**STAFF RECOMMENDATION**

**1403 Beechwood Avenue**

**July 15, 2020**

**Application:** New Construction—Addition and Outbuilding/Detached Accessory Dwelling Unit

Figures 4 & 5 show the changes to the window opening on the left façade.

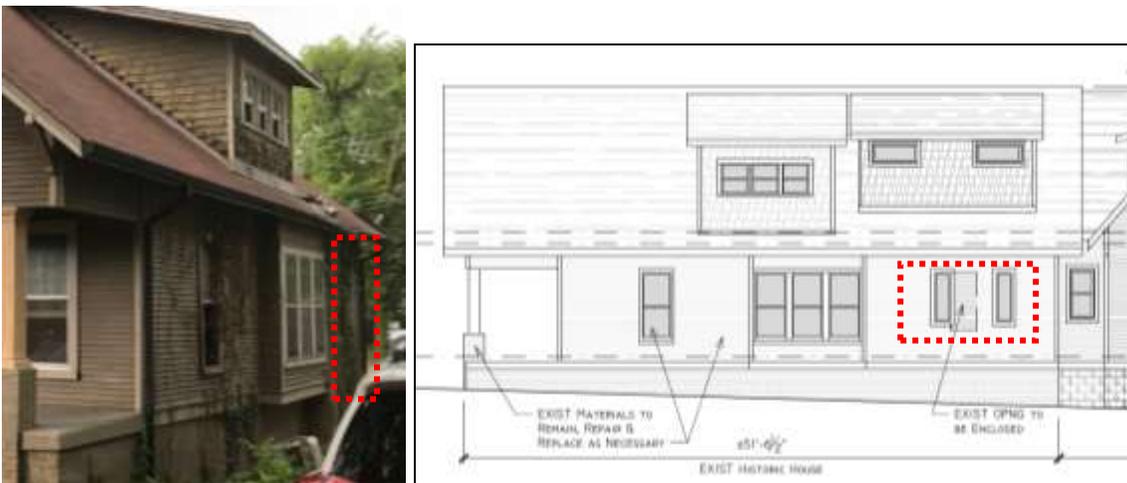
Partial Demolition: The applicant is proposing to alter window and dormer openings on the side facades, which is considered partial demolition. On the right façade, a non-historic door opening will be made into a window and the two windows at the rear will be made into three windows (Figures 4, 5). On the left façade, behind a bay, one window opening will be replaced with two window openings (Figures 6,7). Staff finds that these alterations do not significantly alter the historic character of the house because they are located on the side facades, towards the rear, are not highly visible from the street and maintain openings on the side walls.

Figures 6 & 7 show the changes to the window opening on the right façade.

Staff finds that the proposed partial demolition meets Section V.2. of the design guidelines.

Figure 8. c. 1968 Property Assessor photo of 1403 Beechwood.

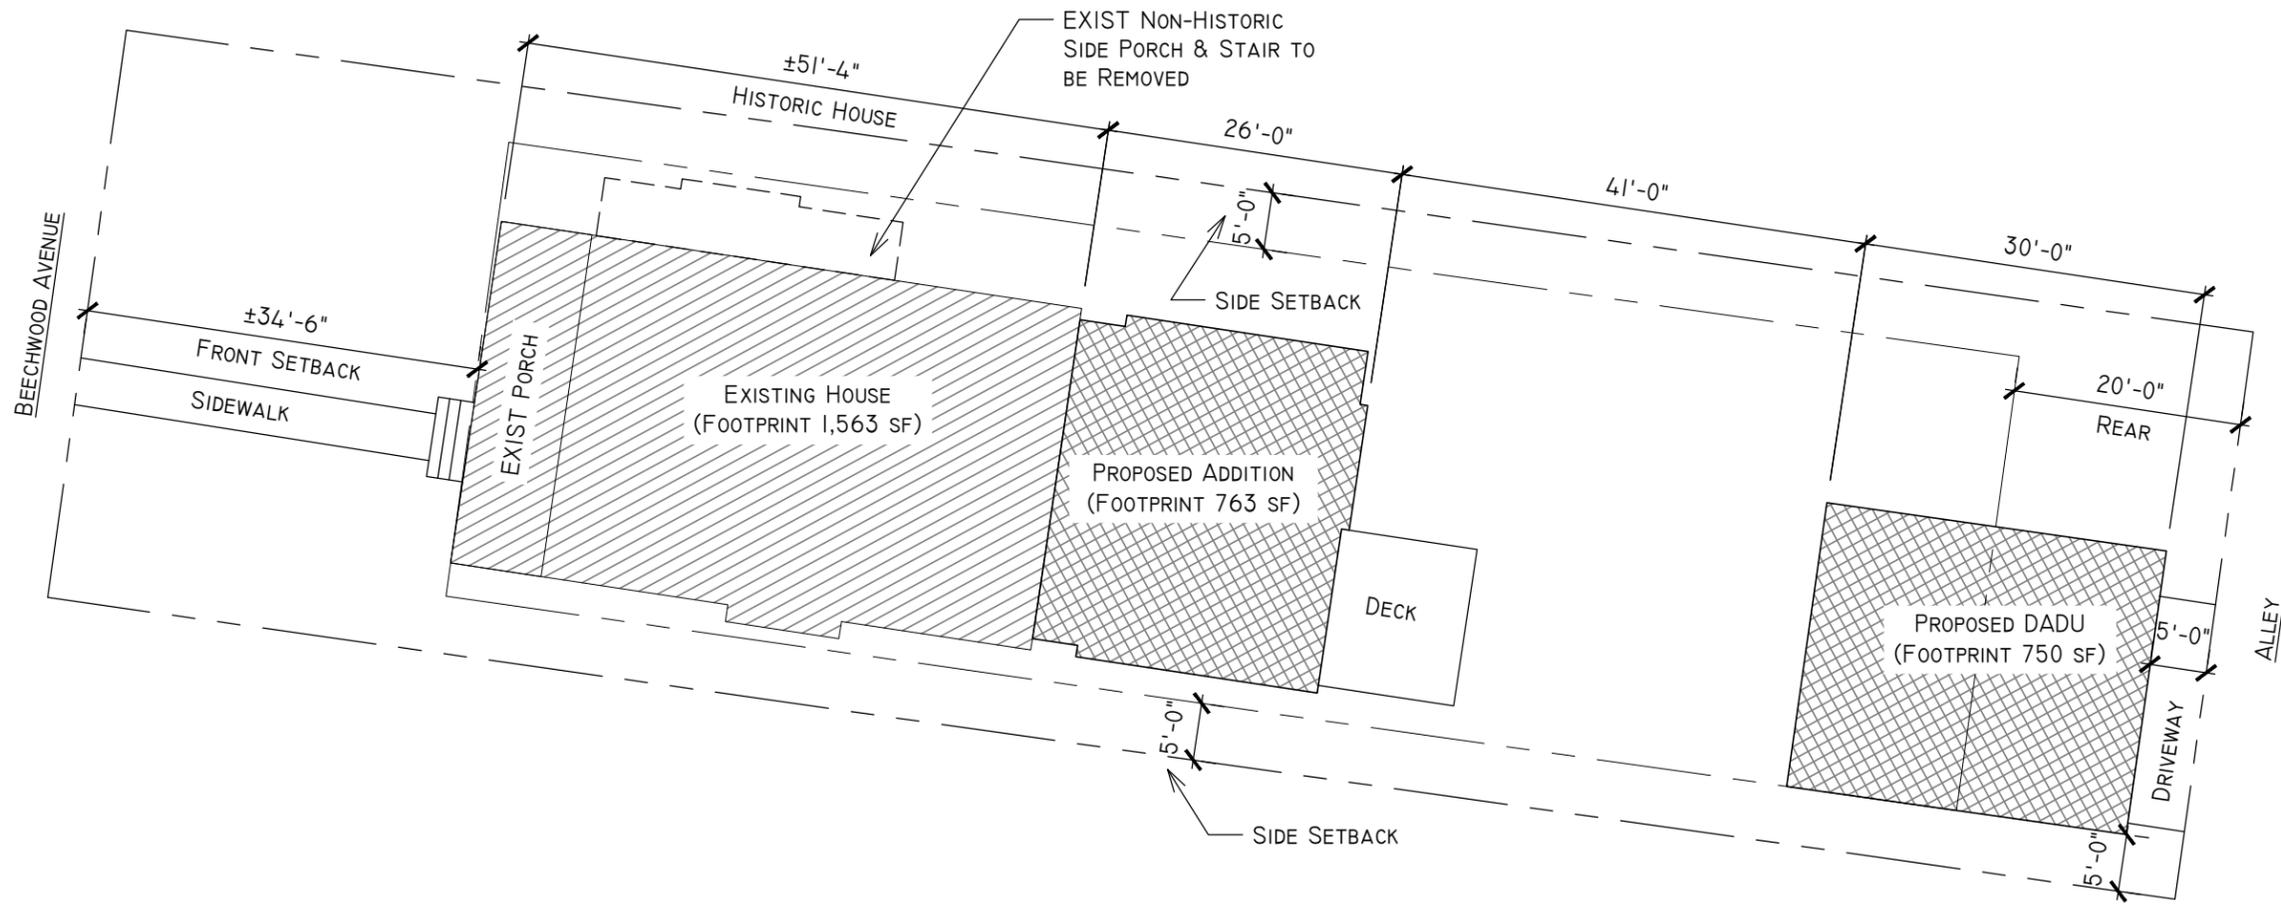
**Roof form:** The project involves adding side dormers to the historic house behind the existing side dormers. The new dormers are inset two feet (2’), as required. Staff finds that the new dormers are too wide. It is not known if the existing dormers are original to the house, but they are seen in the c. 1968 photo (Figure 4). The design guidelines state that *“New dormers should be similar in design and scale to an existing dormer on the building.”* Staff finds that the new dormers are wider than the existing dormers, and recommend that the new dormers be reduced in width to match the widths of the existing dormers, which are about eleven feet (11’) wide. Staff also recommends that the windows be enlarged to more completely fill the front face of the dormer. The new shed dormers will have roof slopes matching the slopes of the existing dormers.

With the condition that the new side dormers be reduced in width to be no wider than the existing dormers, and that the ratio of window to wall on the dormer’s face be increased, staff finds that the proposed roof forms meet Sections II.B.1.e. and II.B.2. of the design guidelines.
